Re Application: 21/02639/FUL Land West of 75 Town Furze,
Oxford OX3 7EW

Second Objection 07.10.2026

Sketch map to show application site (red outline) SSSI limits (pink) land ownership strips and water flow result from log damming of southern marginal drain, 2016. Drawn by Judy Webb from the definitive SSSI limits map supplied to FoLV by Natural England.

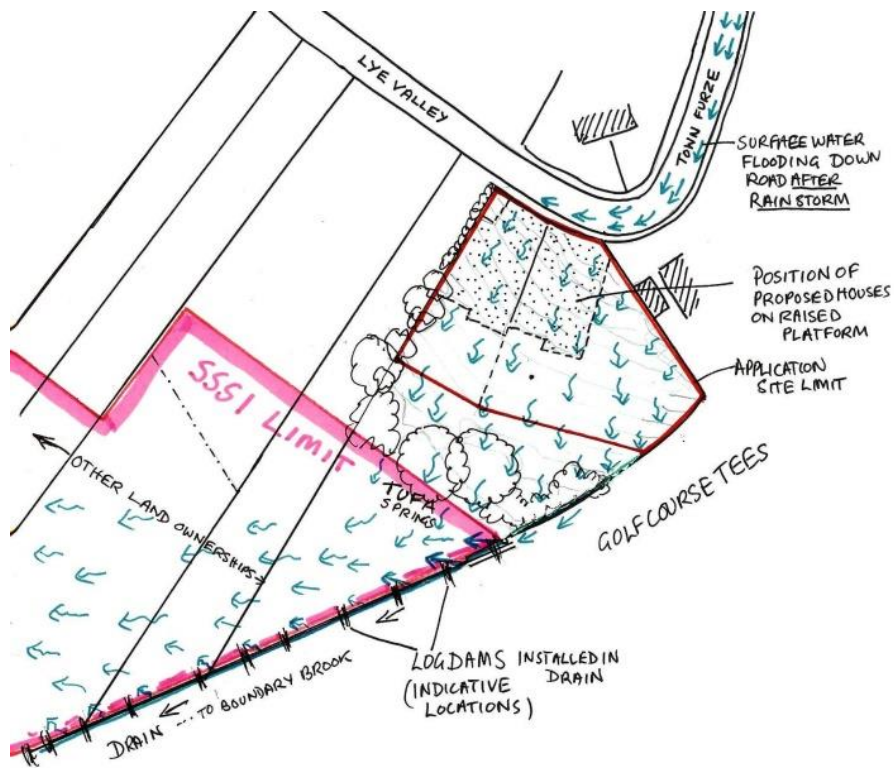
Drain-blocking with water re-direction saved the south fen in recent Climate change-induced severe droughts. Hot and dry summers in the last eight years threatened the survival of the south fen flora and fauna by damaging drying. Fortunately, water was retained in the fen by Natural England's grant-funded drain-blocking (2016) with spring water (groundwater) re-direction into the centre of the site from the south-east marginal drain. The City Council staff and FoLV carried out this work. This **drain water supply originates on the housing application site** (spring and surface flow) as in the diagram below. This shows the current situation of beneficial water redirection; flow from the application site now wets fen areas in a wide part of the south fen **including other land-ownership strips** to the west. It is crucial water flow from the application site is undamaged by development; the survival of the whole

South Fen in future depends on what happens to this re-directed water flow that will help keep the fen alive in coming years.
